DESIGN AND CONSTRUCTION MANUAL DESIGN MODIFICATION REQUEST

PROJECT NAME: LSR7 Middle School #4 – Bailey Road

PERMIT NUMBER: PL2020134

Re: LSR7 Middle School #4 Stream Buffer Variance - PL2020209
Stream Assessment Design Memorandum

13-20102-00
 STREAM BUFFER ENCROACHMENT EXHIBIT

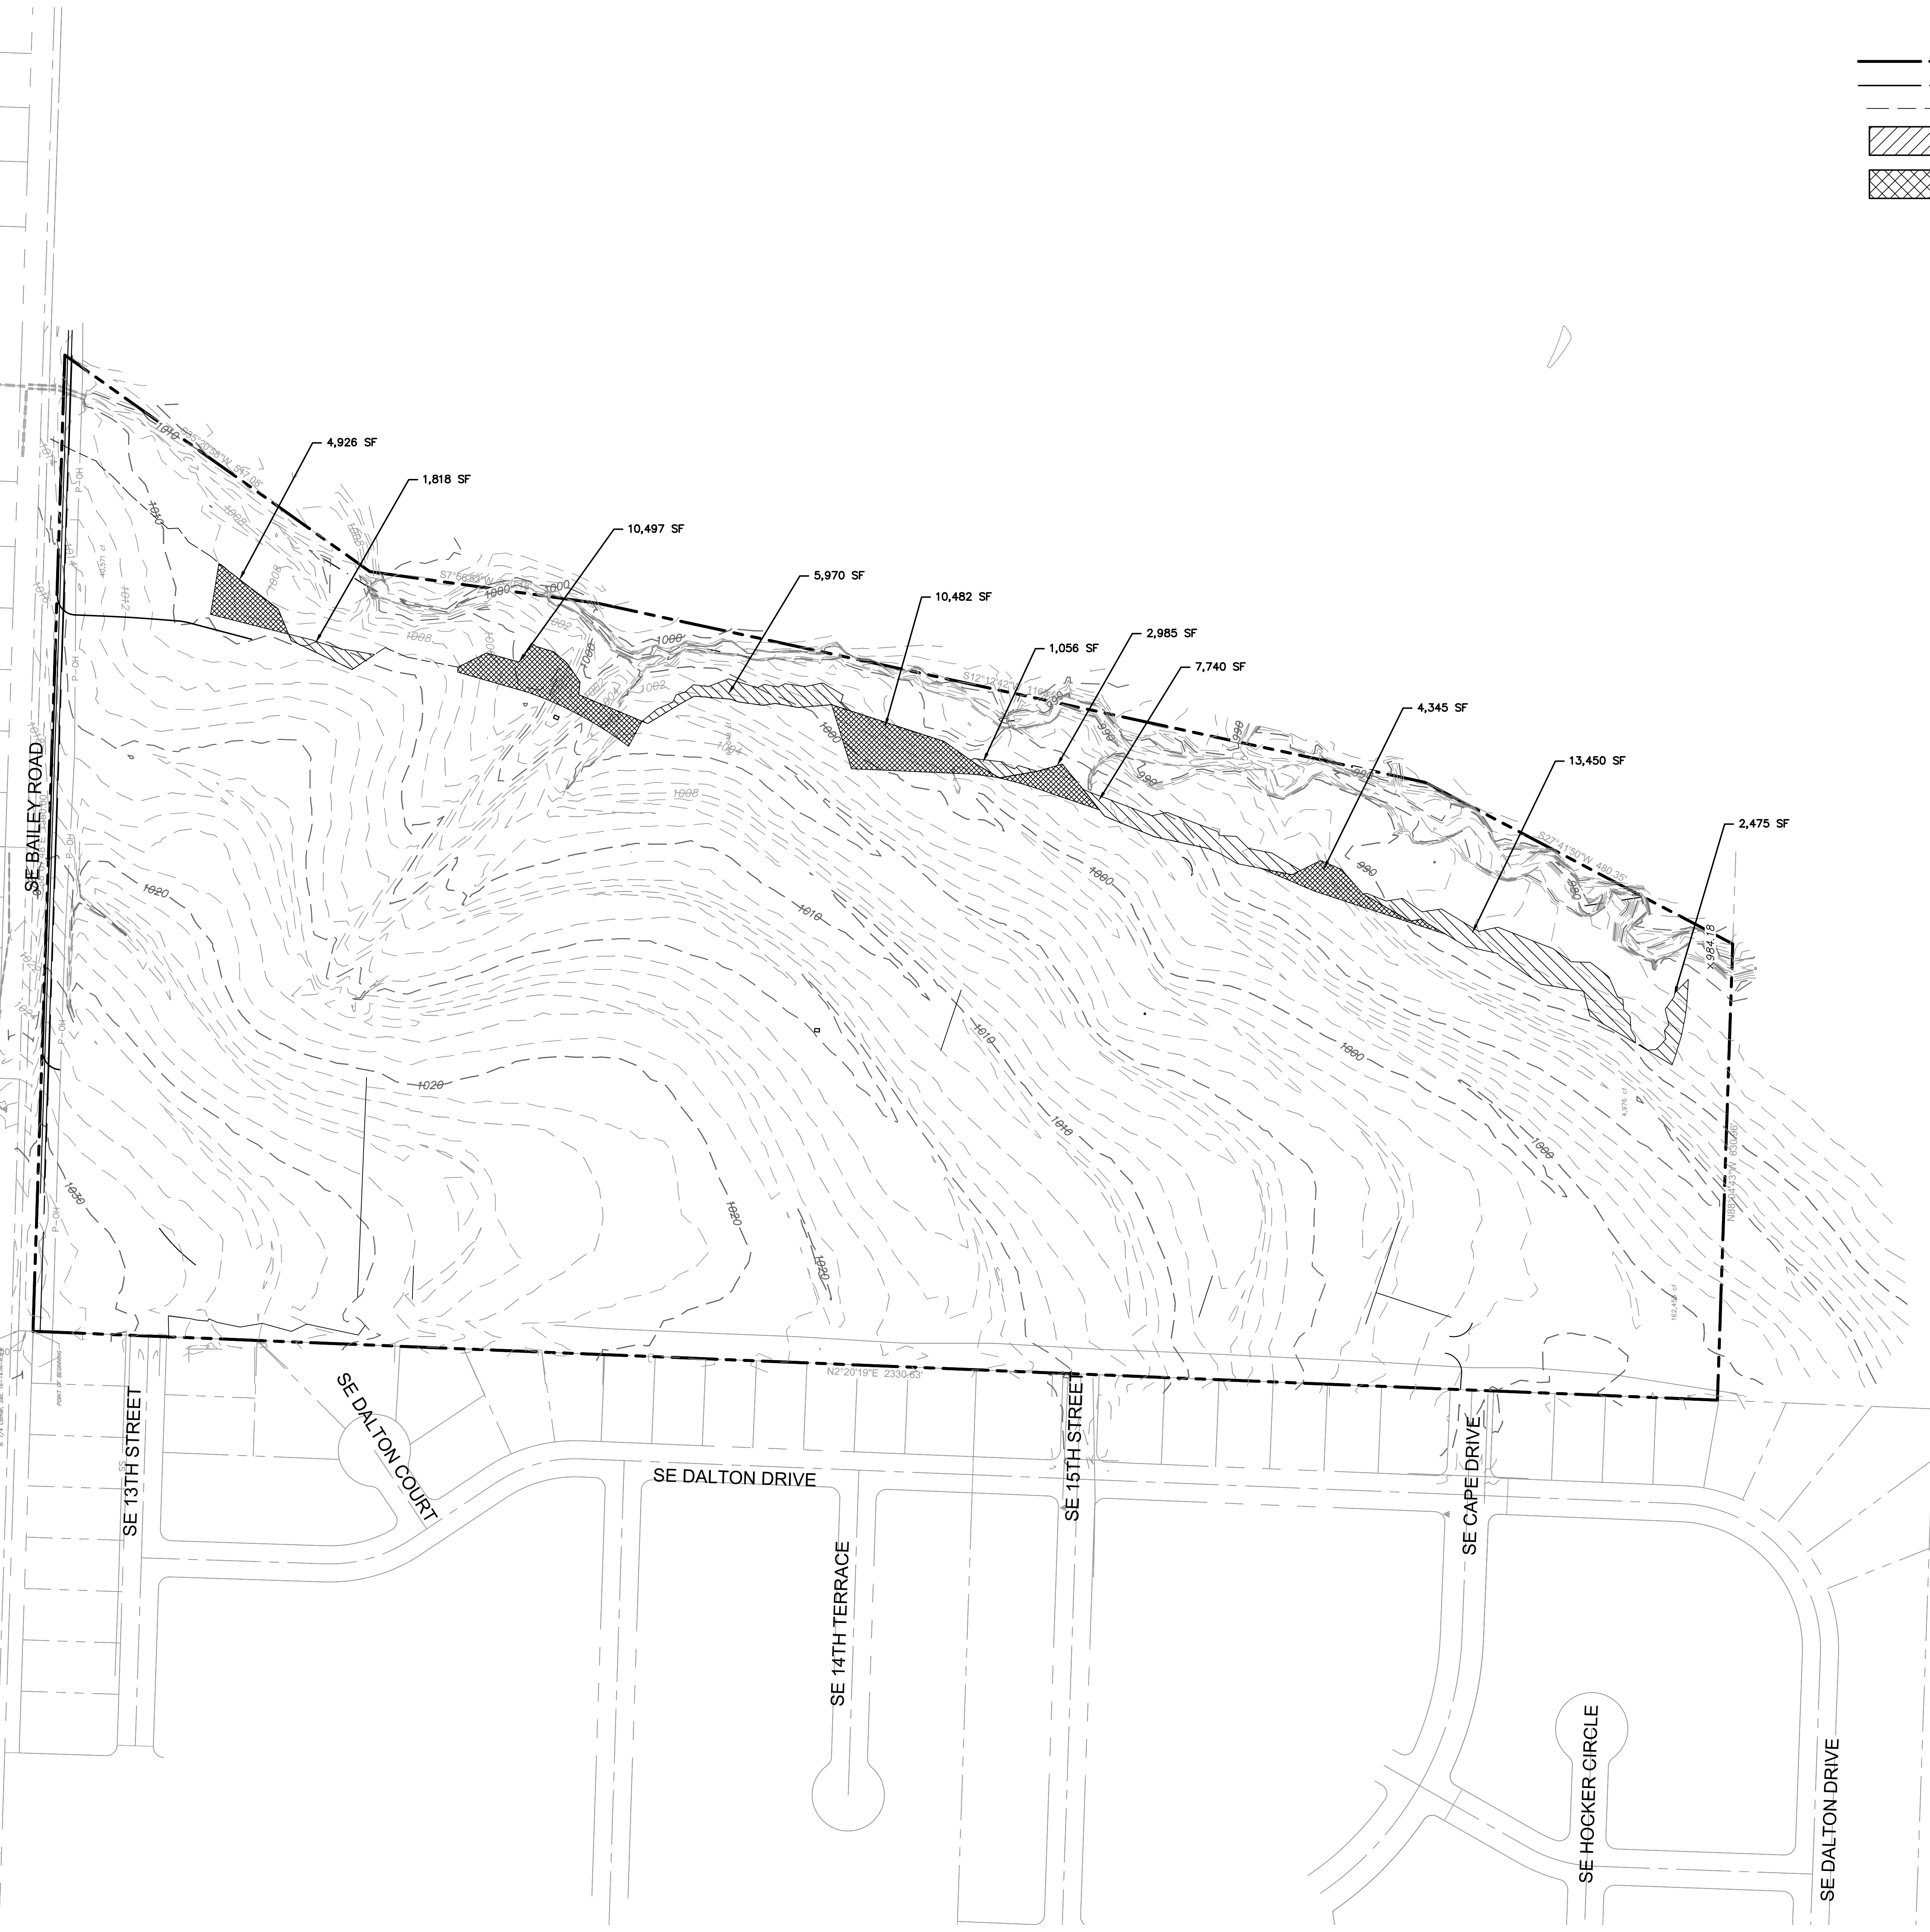
5605.3 Stream Preservation and Buffer Zones – we are requesting a waiver/modification to this section to encroach on the prescribed stream buffer widths in specific areas as identified on the attached drawings. Our encroachment is needed due to the nature of the site being narrow in the east/west direction and meeting the program requirements for all of the components needed on site by the school district. The grade of the site falls from west to east towards the existing streamway. Again, with the narrow site it is difficult grade out the site for buildings, fields, and parking and not have the slope embankment encroach into the buffer.

According to the requirements of Section 5605.3, a total of 2.08 acres should be dedicated to the stream setback. To accommodate the improvements noted above a total of 0.74 acres will have to be removed from the 1.34 acres. Per Exhibit 1 in this submittal. An additional 0.76 acres will be added to the easement. This results in 2.10 acres of permanent stream setback dedication.
